**STAFF REPORT
KETCHUM PLANNING AND ZONING COMMISSION
MEETING OF JULY 16, 2026**

PROJECT:	Greyhawk Townhomes
FILE NUMBER:	P26-008
APPLICATION TYPE:	Preapplication Mountain Overlay Design Review
PROPERTY OWNER:	Andrew Seligson & Sarah Toral
ARCHITECT:	Mike Allaire, AIA, Michael Doty Associates Architects
REQUEST:	Preapplication Mountain Overlay Design Review for the construction of two three-story duplex buildings and associated site improvements
LOCATION:	Tax Lot 6866 (RPK4N170140730), on the north side of Warm Springs Road at the western edge of the Ketchum city limits
ZONING:	General Residential Low Density (GR-L)
OVERLAY:	Mountain Overlay and Avalanche Overlay Districts
REVIEWER:	Abby Rivin – Senior Planner
NOTICE:	A public hearing notice was mailed to all property owners within 300 feet of the project site on June 24, 2026. The notice was published in the Idaho Mountain Express on June 24, 2026. A notice was posted on the city's website on July 1, 2026 and on the project site on July 9, 2026.

Figure 6: Proposed Building Orientation and Hillside Site Design

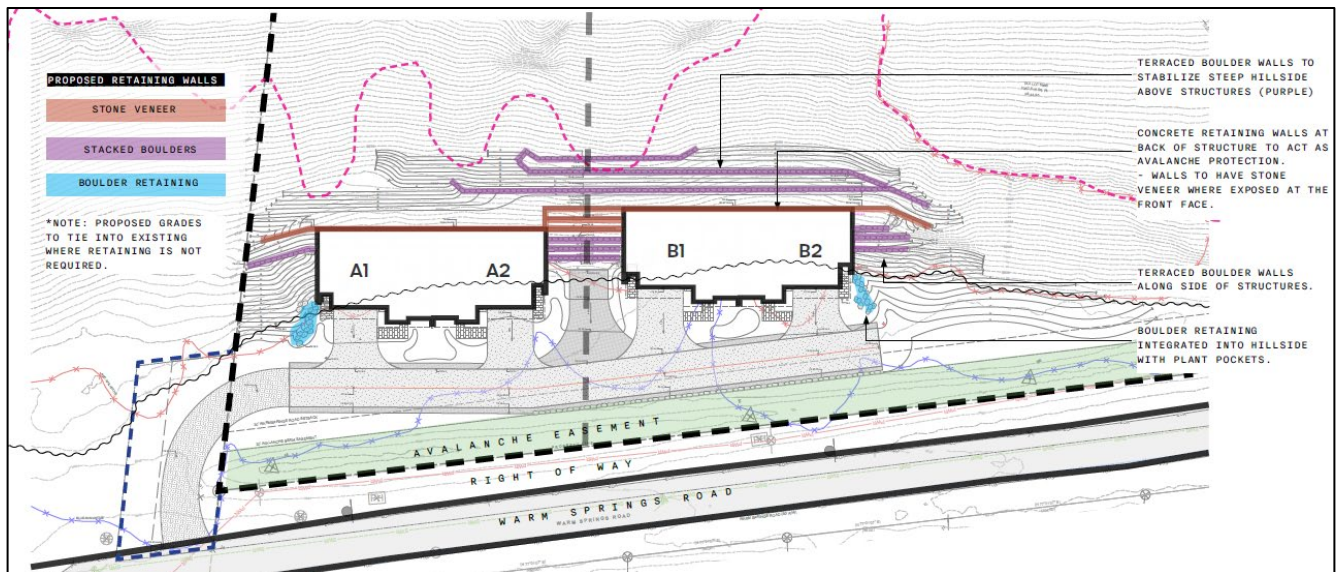
Additional opportunities remain to improve the relationship between the buildings, Warm Springs Road, and the surrounding hillside through adjustments to building orientation, spacing, and site planning. Additional variation in the placement of the duplex buildings and individual units would reduce the perception of repetitive building forms while better responding to the site's natural topography.

L2.11 ACCESS + FIRE DEPT

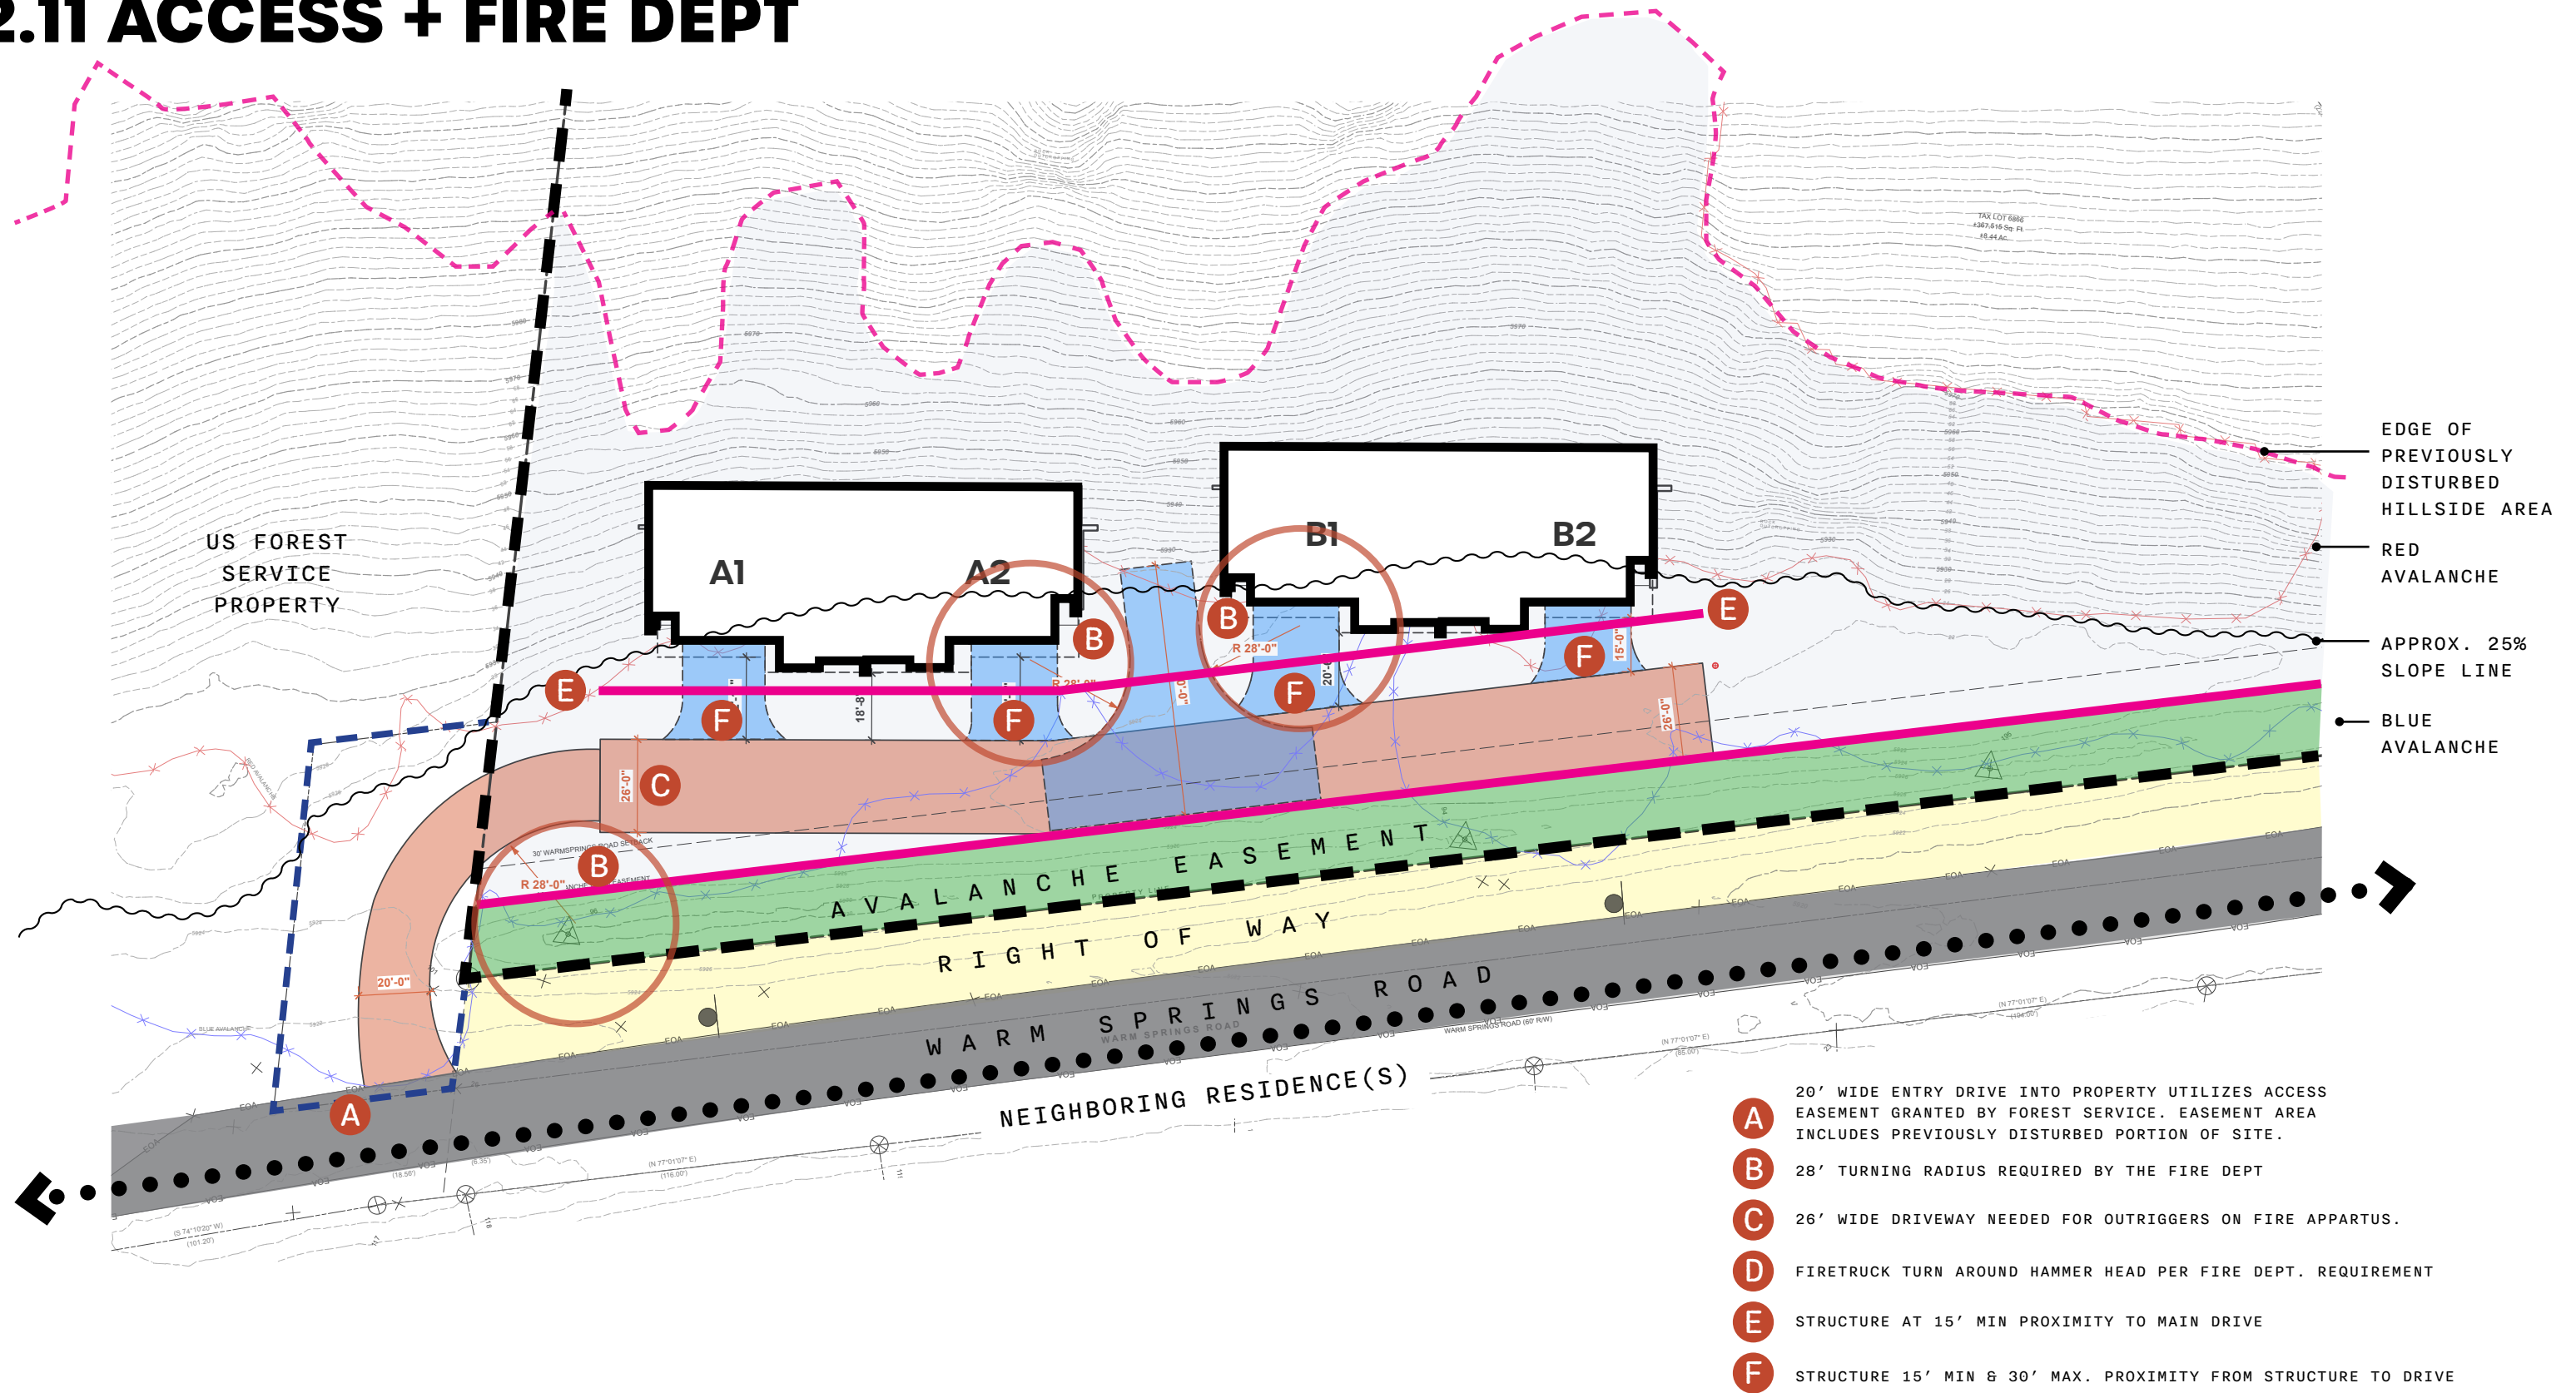
In addition, the City Engineer has noted that the required 28-foot turning radius shown on Sheet L2.11 may have flexibility to shift closer to the avalanche easement. Refinement of the access drive geometry, together with corresponding adjustments to the placement of Building A while maintaining required fire separation distances, may further reduce encroachment into the hillside.

GROSS AREA PLANS AND CALCULATIONS

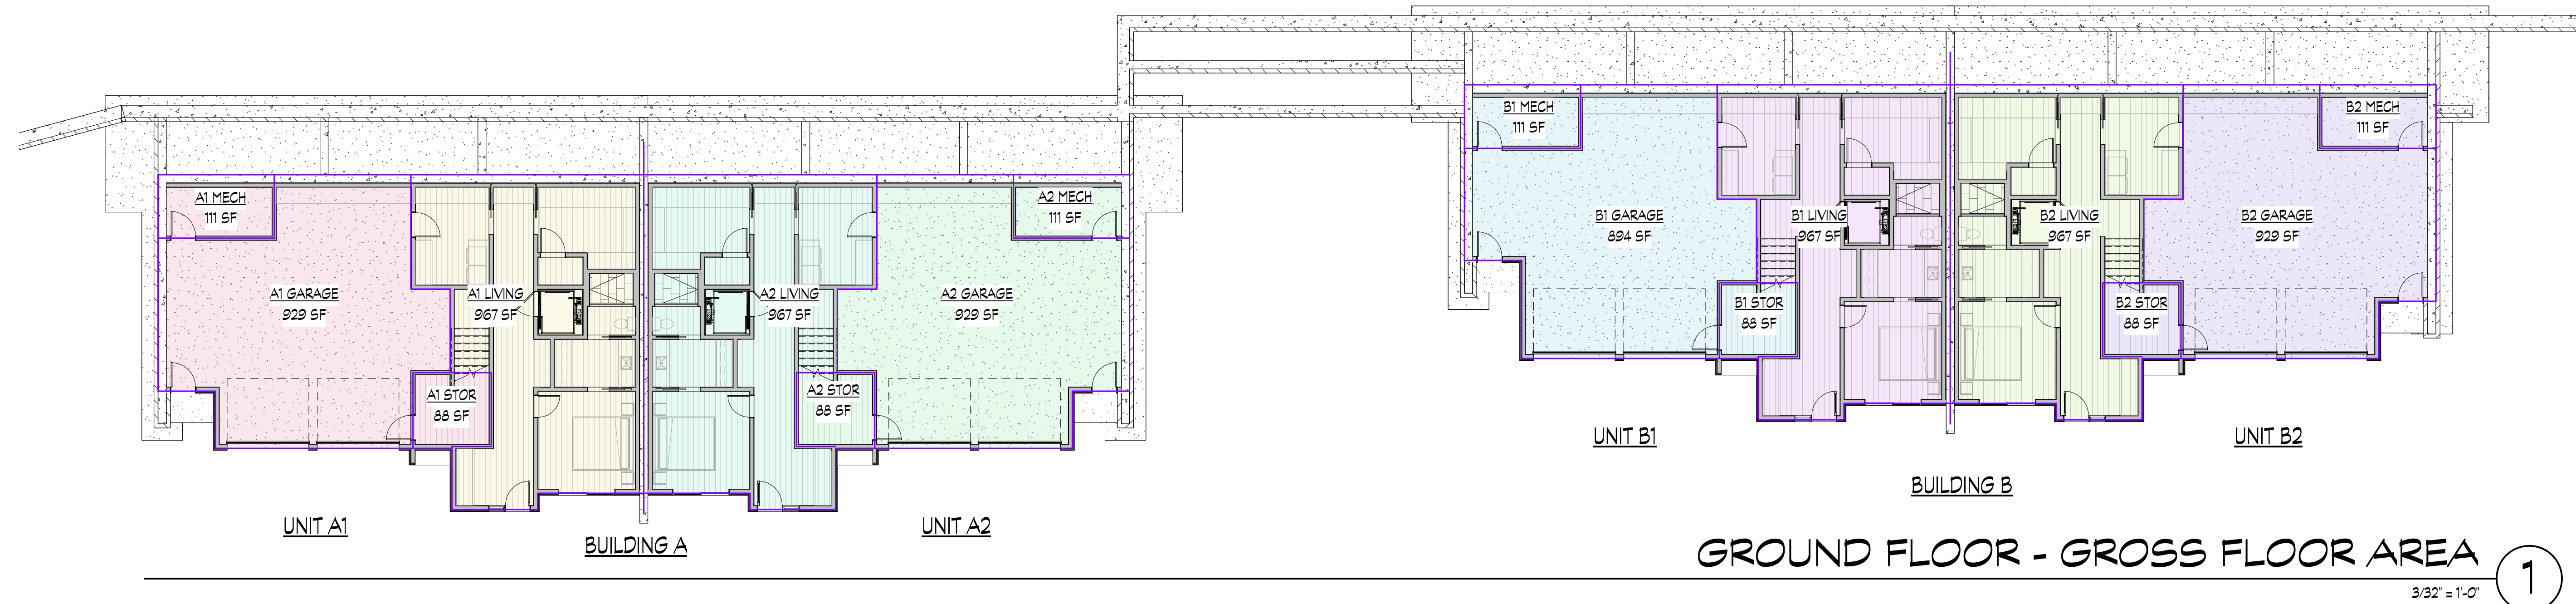
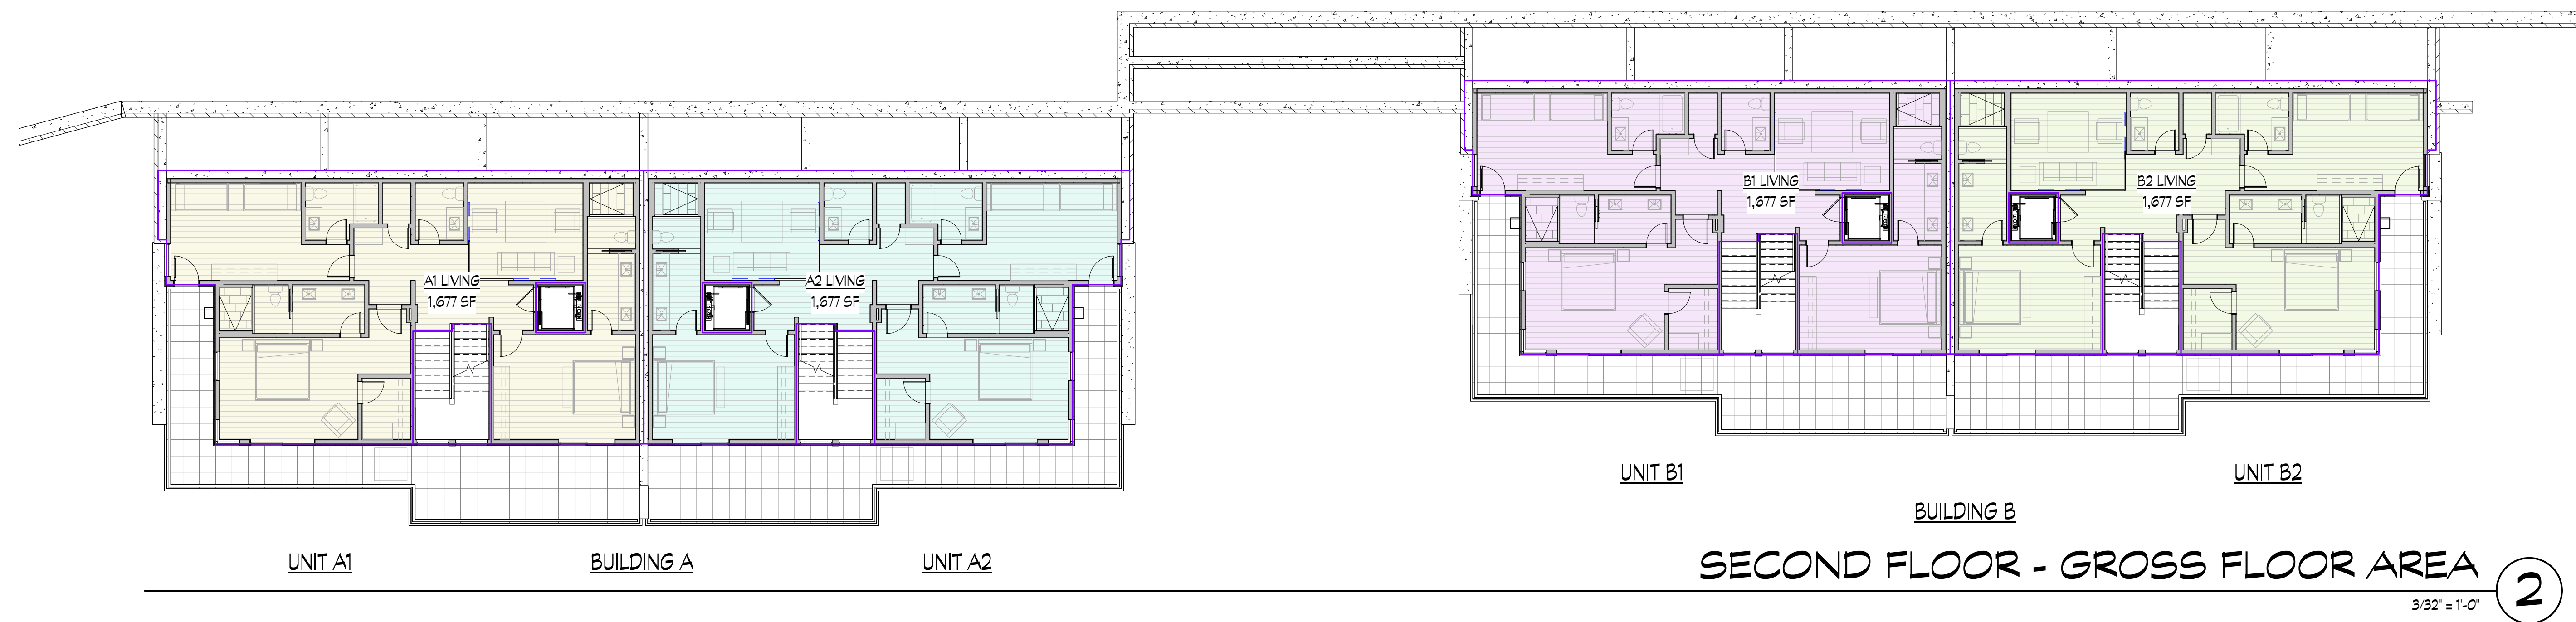
Sheet A-010 identifies total building coverage for the existing Tax Lot 6866 as 11,882 square feet, or 3.2 percent of the total lot area. However, staff cannot verify compliance with the building coverage
